Work Order ID: 124537

Item ID: D407-667-205 Accept *N900040100* Setup Start *NS1*
 Revision ID: Stop *NS2*
 Item Name: Aft Crosstube - High 407
 Start Date: 9/12/2014 Start Qty: 1.00 *1* Cust Item ID:
 Required Date: 9/12/2014 Req'd Qty: 1.00 *1* Customer:
 Reference:

DRAWING NO. D407-667-245		REV. F	SHEET 1 OF 4
TITLE CROSSTUBE ASS'Y (407 HIGH AFT)		SCALE	NTS
COPYRIGHT © 2002 BY DART AEROSPACE LTD THIS DOCUMENT IS PRIVATE AND CONFIDENTIAL AND IS SUPPLIED ON THE EXPRESS CONDITION THAT IT IS NOT TO BE USED FOR ANY PURPOSES OR COPIED OR COMMUNICATED TO ANY OTHER PERSON WITHOUT WRITTEN PERMISSION FROM DART AEROSPACE LTD.

DRAWING NO. D407-667-245	TITLE CROSSTUBE ASSY (407 HIGH AFT)	REV. F	DART AEROSPACE LTD ENGINEERING ORDER		D.E.O. NO. D407-667-245-F-1	SHEET NO. SHEET 1 OF 2	SCALE NTS
DRAWN	CHECKED	MFG. APPR.	APPROVED	DE APPR.			
DATE 11.04.08	DATE 11.04.12	DATE 11.04.12	DATE 11.04.12	DATE 11.04.12

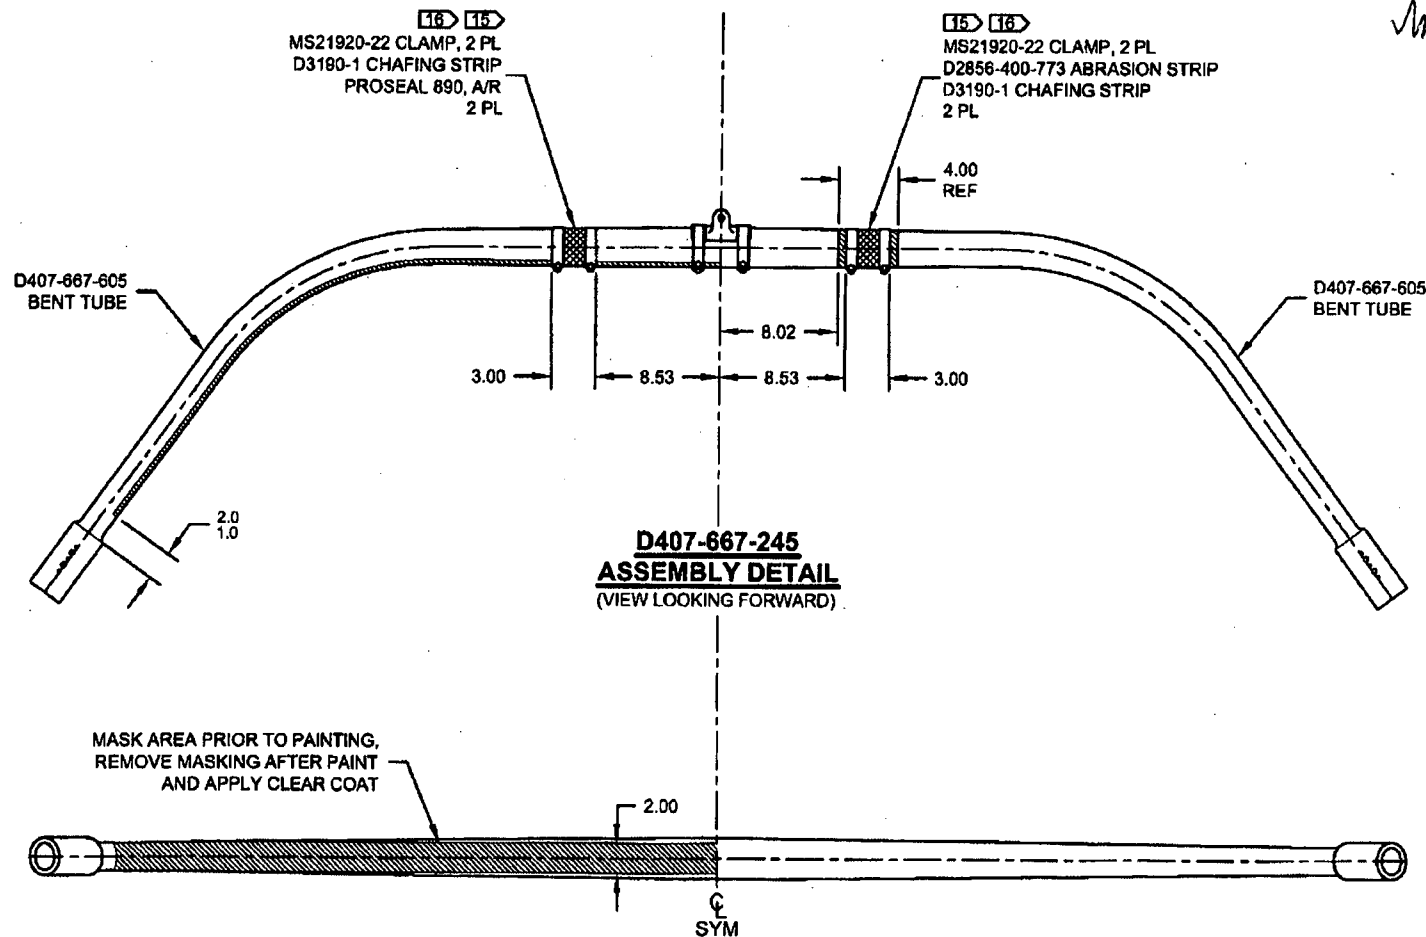
NOTES 2 AND 15, SHEET 1 ARE AMENDED AS FOLLOWS:

- 2) FINISH: CHEMICAL CONVERSION COAT PER DART QSI 005 4.1
PRIME INSIDE AND OUTSIDE PER DART QSI 005 4.2
MASK UNDERSIDE OF CROSSTUBE AS SHOWN (HATCHED AREA) AND
PAINT OUTSIDE PER DART QSI 005 4.2
REMOVE MASKING AND APPLY CLEAR COAT
- 15) APPLY A THIN COAT OF PROSEAL 890 ON INSIDE CONCAVE SURFACE OF D3190-1
CHAFING SHIELDS AND LET CURE PER MANUFACTURER'S INSTRUCTIONS. INSTALL
PROSEALED D3190-1 CHAFING SHIELDS ONTO CROSSTUBE BY APPLYING A THIN COAT
OF PROSEAL 890 ONTO CROSSTUBE. BE SURE TO ELIMINATE ANY AIR GAPS.

IS:

WAS:
